Table 1. Response to Observations

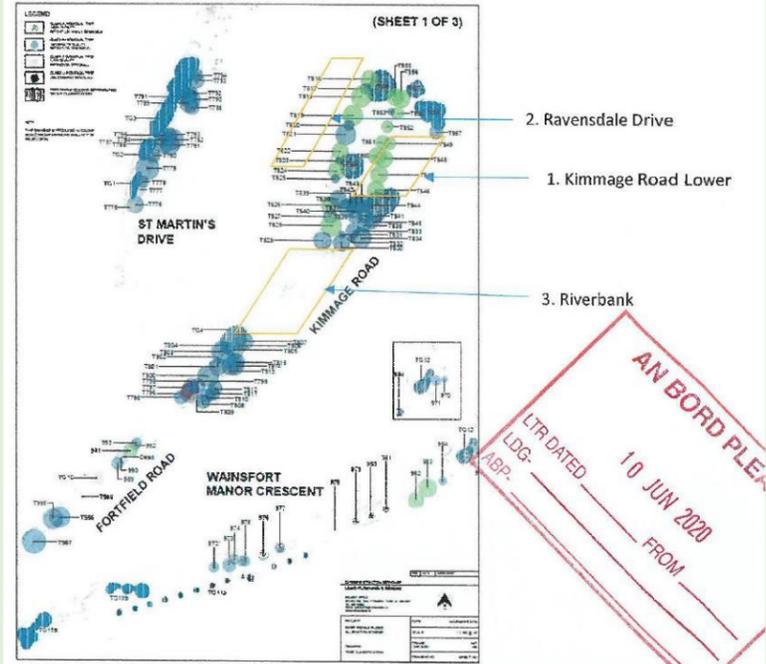
Name	Observation no.	Observation/Issue	Response
		<p>4. Having completed the work, the archaeologist should submit a written report to the Planning Authority and to this Department.</p> <p>5. Where archaeological material is shown to be present, avoidance, preservation in situ, preservation by record or (excavation) and/or monitoring may be required. The Department of Culture, Heritage and the Gaeltacht will advise the Planning Authority with regard to these matters.</p> <p>6. No site preparation or construction work should be carried out until after the archaeologist's report has been submitted and permission to proceed has been received in writing from the Department of Culture, Heritage and the Gaeltacht.</p> <p>The Wade and Metal Detection Survey shall be compiled as follows:</p> <p>1. The applicant is required to engage the services of a suitably qualified archaeologist to carry out Wade and Metal Detection survey in all areas where the Poddle riverbed shall be disturbed by the works. This should be licenced under the National Monuments Act 1930-2004.</p> <p>2. The metal detection survey should be carried out under licence granted under section 2 of the National Monuments Act 1987.</p> <p>3. Having completed the work, the archaeologist shall submit a written report to this Department for review.</p> <p>4. Where archaeological material/features are shown to be present, preservation in situ, avoidance, preservation by record (archaeological excavation) or archaeological monitoring may be required.</p> <p>The applicant shall be prepared to be advised by the Department of Culture, Heritage and the Gaeltacht in this regard.</p> <p>It should be borne in mind, that if significant archaeological remains are found, further archaeological mitigation might be required. Reason: To ensure the continued preservation (either in situ or by record) of places, caves, sites, features or other objects of archaeological interest.</p> <p>Having examined the documentation submitted in support of the present application, the NPWS of this Department very much welcomes the approach which has been adopted by the applicants in evaluating and mitigating the impacts of the proposed River Poddle Flood Alleviation Scheme on the flora and fauna occurring along the sections of the Poddle which will be affected by it, as well as avoiding any impacts on the Natura 2000 Sites present downstream in Dublin Bay. Given the constraints involved in constructing a flood alleviation scheme on a largely urban water course, the applicants appear to have incorporated measures in the proposed scheme in as far as was feasible to preserve the existing flora and fauna occurring on the Poddle. To compensate for some inevitable loss of trees and semi-natural vegetation, much tree planting is proposed as well as measures to allow the re-establishment of species rich meadow areas. The habitat enhancement measures proposed are also very worthwhile, including the construction of nesting platforms and artificial sand banks to encourage nesting by sand martins and kingfishers on Tymon Lake.</p> <p>This Department considers that such provision of refuges and breeding places for bird species should in addition be extended to otters. Though, as reported in the Environmental Impact Assessment Report, otter surveys in 2018 and 2019 found no evidence of the presence of otters on the Poddle, as also stated in this document there have been occasional reports of otter sightings in Tymon Park in recent years, particularly</p>

Name	Observation no.	Observation/Issue	Response
		<p>circa 2016. In the future improved water quality on the Poddle may lead to the re-establishment of sufficient fish stocks to allow a permanent presence again by otters on this stream. To facilitate otter re-colonisation artificial otter halts should be provided on or near the ponds in Tymon Park on either side of the M50, and if possible, further downstream as well. Such halts would provide resting and breeding places for these animals secure from human or canine interference. Similar holts installed elsewhere in Dublin have been readily occupied by otters, for instance by the Aviva Stadium on the Dodder.</p> <p>Considerable numbers of trees and shrubs are to be removed to facilitate the flood alleviation works. These are likely to harbour nesting birds during the bird breeding season.</p> <p>In the light of the above the Department of Culture, Heritage and the Gaeltacht recommends the following conditions should be attached to any permission granted by An Bord for the proposed flood alleviation scheme:</p> <ol style="list-style-type: none"> <li>1. That artificial otter halts are to be provided on or near the ponds in the two parts of Tymon Park on either side of the M50, the design of these holts to be agreed with the South Dublin County Dublin Heritage Officer and the National Parks and Wildlife Service; halts also be installed downstream in the vicinity of Whitehall Park and/or Poddle Park depending on space and design constraints. Reason: To conserve the otter, a species afforded a regime of special protection under the Habitats Directive (92/43/EEC).</li> <li>2. That any clearance of vegetation from the banks of the Poddle or adjacent areas as part of this scheme should only take place outside the main bird nesting season i.e. in the period from September to February inclusive. Reason: To avoid the destruction of nests, eggs, and nestlings of protected bird species.</li> </ol>

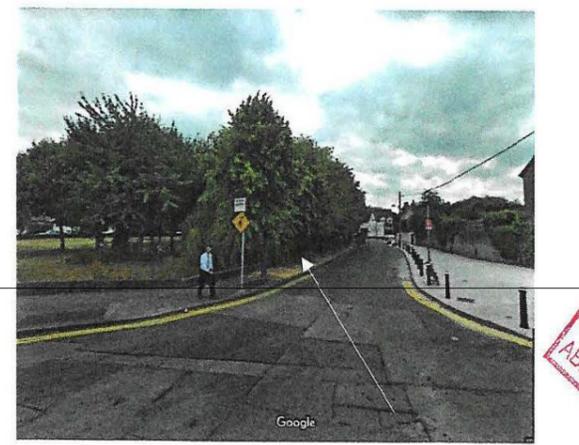
24.2	<p>The value of amenity grasslands for Geese is outlined in section 3.4 of the NIS: "Brent Geese also fly inland to feed on amenity grasslands in parks and sports fields around Dublin city. These areas are not included within the SPAs, but are important supporting habitat features for this species. " And we would highlight the importance of these areas, given that in the past planning permission has been refused by An Bord Pleanála on the grounds that the development would potentially impact on the inland feeding grounds of Brent Geese (St. Anne's Park), a qualifying interest of nearby SPAs.</p> <p>An Taisce would highlight that there is conflicting evidence provided in the planning documentation in regard to Brent Geese. In the NIS no threat is identified to Brent Geese (which is a qualifying interest of two nearby SPAs, Bull Island SPA and South Dublin Bay and Tolka Estuary SPA) by the works, and Table 3.1 indicates that the NPWS did not respond to a consultation (although it is unclear to us what this consultation was, or when it was carried out). However, we would observe that in Table 3.1 of the EIAR, it is indicated that the DCHG, which has departmental responsibility of the NPWS, had the following response during the EIA scoping exercise in early 2019: "Brent Geese were present again this winter. This is relevant also to the Appropriate Assessment since Brent Geese are qualifying interests for both Bull Island SPA and South Dublin Bay and Tolka Estuary SPA."</p> <p>An Taisce submit that it is clear that the potential impact of the works on Brent Geese</p>	<p>Response provided in RFI no. 18. A revised Natura Impact Statement is also provided with the RFI response.</p>

Name	Observation no.	Observation/Issue	Response
		<p>should have been specifically assessed in the NIS. It is considered that in failing to even identify the potential impact on Brent Geese, one which the applicant was made aware of by the DCHG during the EIA scoping process, the NIS fails to provide the necessary level of detailed assessment upon which the Relevant Authority can rely in order to carry out a full Appropriate Assessment. The requirements under article 6(3) of the Habitats Directive were made clear by OEU ruling for C-404/091 which held that: [a]n assessment made under Article 6(3) of the Habitats Directive cannot be regarded as appropriate if it contains gaps and lacks complete, precise and definitive findings and conclusions capable of removing all reasonable scientific doubt</p> <p>While the EIAR makes further reference to the Brent Geese and bird surveys which were carried out, an NIS is a standalone legal document, one which we submit is currently failing to assess potential impacts on Brent Geese at all. It is our considered opinion that the NIS cannot provide the relevant authority with the necessary precise and definitive findings which are required for the purposes of an Appropriate Assessment, and that to rely on this document for the purposes of an Appropriate Assessment would be a compliance failure of Article 6(3) of the Habitats Directive.</p> <p>Without prejudice to our comments on the failure of the NIS to assess the potential impact on Brent Geese, the EIAR contains what we perceive to be conflicting data on Brent Geese. The EIAR presents a range of anecdotal evidence to suggest that Tymon Park is no longer used by Brent Geese. For example in Chapter 7 of the EIAR it outlines that: "Based on anecdotal evidence, Brent Geese have not used Tymon Park in recent years as a result of constant disturbance by dogs. In addition, a dog park was built next to the area that was used by Brent Geese in the fields at the north end of Tymon Park East. Construction activity was noted during the survey period."</p> <p>And in Table 3.2 of Chapter 7 it quotes a number of anecdotal responses to an unidentified consultation. However, An Taisce would observe that these should not be relied upon, given their anecdotal nature. We acknowledge that bird surveys were carried out over several months in early 2018, during which no Brent Geese were observed to use the park. However, in Chapter 7 of the EIAR it is acknowledged that: "A flock of Brent geese was observed by the SDCC Heritage Officer on the 4th of February 2019 (pers. comm.) on playing fields in the north-west of the park. The playing fields were subsequently surveyed by NM Ecology Ltd. in early March 2019 to search for goose droppings or other signs of activity, but no evidence was found"</p> <p>In addition, during the EIA scoping exercise in early 2019, the DCHG indicated that geese were present in the park that winter. An Taisce assume this submission was from the NPWS, who must be viewed as the ultimate authority in this case given their role as the designated governmental body for the protection of flora and fauna. As such, while anecdotal evidence and a limited number of bird surveys would indicate that the park is no longer used by Brent Geese, both the DCHG and the SDCC Heritage Officer present evidence to the contrary. This discrepancy is not addressed in the EIAR, and An Taisce would highlight that an unresolved question remains regarding the use of the park by Brent Geese.</p>
